EB-2006-0189 – Hydro One Networks' Application for Approval of Connection Procedures Pursuant to the Transmission System Code– Hydro One Networks' Reply Submission

Hydro One Customer Connection Procedures (EB-2006-0189)

Hydro One Reply Submission

Transmission Plans

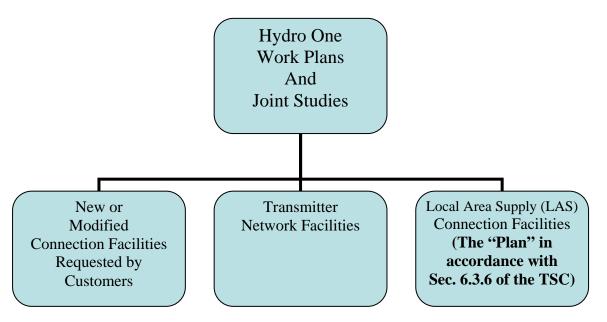
OEB Staff made submissions about the "Transmission Plans" that Hydro One has proposed to provide to customers as per section 6.3.6 of the TSC. OEB Staff's main issue is that Hydro One proposes to exclude certain classes of plans from the requirement set out in section 6.3.6 of the TSC. The exclusions cover situations that are classed as either customer-driven or network facilities.

OEB Staff's submission refers to the list of facilities that will be excluded from the Plan referred to in section 6.3.6 of the TSC for the purpose of determining whether capital contribution is required. The Plan referred to in this context is not intended for the purpose of providing a "complete picture" of the transmission system expansion in any

Hydro One's proactive planning process ensures that Hydro One works with customers to find solutions to connect customers and provide a safe, secure and reliable power supply. Hydro One works together with customers through joint work plans and studies to ensure that reliable supply is provided. These work plans and joint studies may include any of the three types of facilities illustrated in the chart below.

For the purpose of Section 6.3.6 of the TSC, i.e. for the purpose of determining whether capital contribution is required other than for advancement costs, the connection facilities referred to in this section of the TSC will only include the Local Area Supply (LAS) connection facilities as indicated in Section 3.0 of the Customer Connection Procedures. Connection facilities other than LAS facilities may be part of a joint study in which Hydro One participated but not necessarily part of the Plan referred to in Section 6.3.6 of the TSC.
